Subject: PowerGrip® Kit K015432XS for Fiat and Lancia 1.6 petrol engines

On OE(S) level the synchronous tensioner on these engines has changed already three times. Our kit has always reflected those changes in the course of the years. Since the latest evolution looks quite different to the previous ones, we want to give this overview.

Fig. 6 **E**

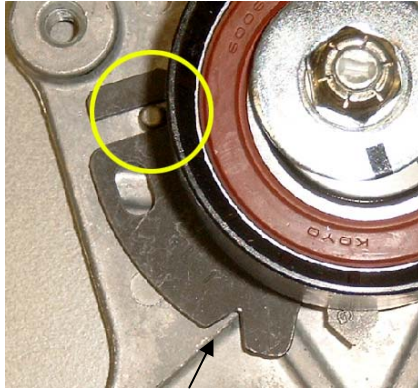
To lock the tensioner, position the open oblong hole in the base plate of the tensioner on the pin on the bracket (Fig. 6).
When the belt and the tensioner are replaced following OE guidelines⁽¹⁾ and after two engine revolutions, then the pointer (**D**) has to be in the middle of the "V" in the base plate of the tensioner (**E**).
At that moment the two black marks (**F**) will also be aligned. Only then the tensioner is correctly installed.
